Amendments to the Drawings:

REMARKS

FIG. 4

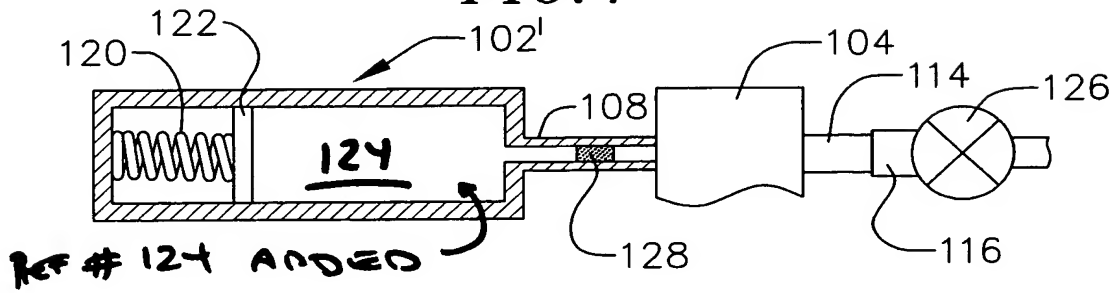
The attached sheet of drawings includes changes to Figure 4. This sheet, which includes Figures 4-6, replaces the original sheet including Figures 4-6. In Figure 4, reference numeral "124" has been added.

Applicant respectfully submits that the objection to the drawings has been obviated by the addition of reference numeral "124" to Figure 4.
